EXTENSIONS, ALTERATIONS AND NEW ANCILLARY BUILDING

L'ORTOLAN PROPOSED ELEVATIONS

ADDRESS:  
L'ORTOLAN, CHURCH LANE  
SHINFIELD, READING, RG2 9BY

JOB No	DRAWING NUMBER
1149	P15 revB
A3 Sheet

SW ELEVATION – ENTRANCE

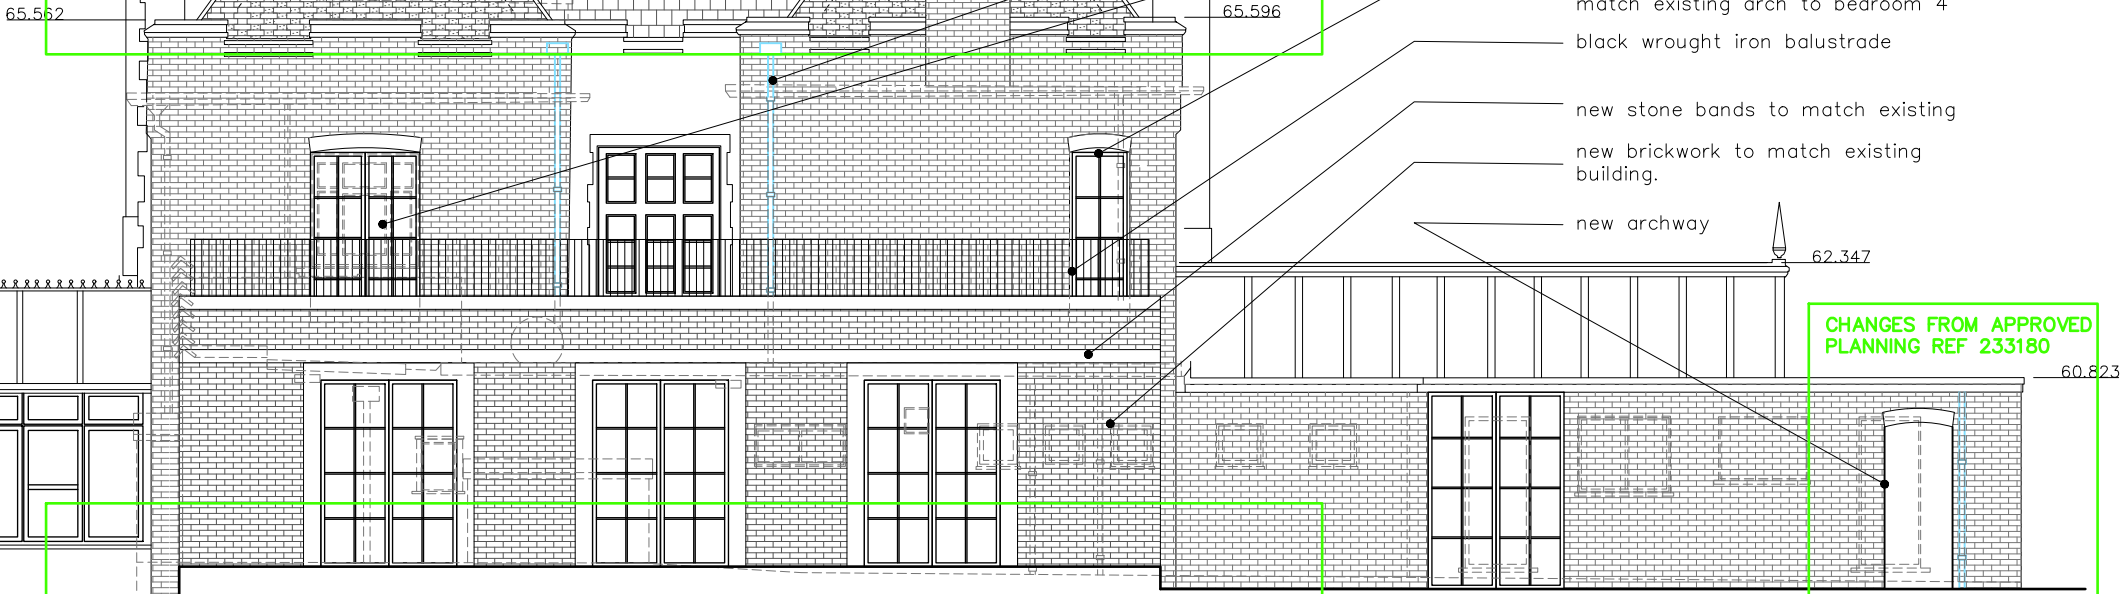
CHANGES FROM APPROVED PLANNING REF 233180

- Hit-and-Miss brick wall gable end
- old chimneys to be reinstated as per original design or similar
- slate pitched roof

CHANGES FROM APPROVED PLANNING REF 233180

- extend chimney
- Hit-and-Miss brick wall gable end
- old chimneys to be reinstated similar to original design or similar new hoppers and downpipes shown in blue, downpipe position as per existing
- existing opening lowered and new white metal french doors added new white metal door in new opening. brick arch above to match existing arch to bedroom 4
- black wrought iron balustrade
- new stone bands to match existing building.
- new archway
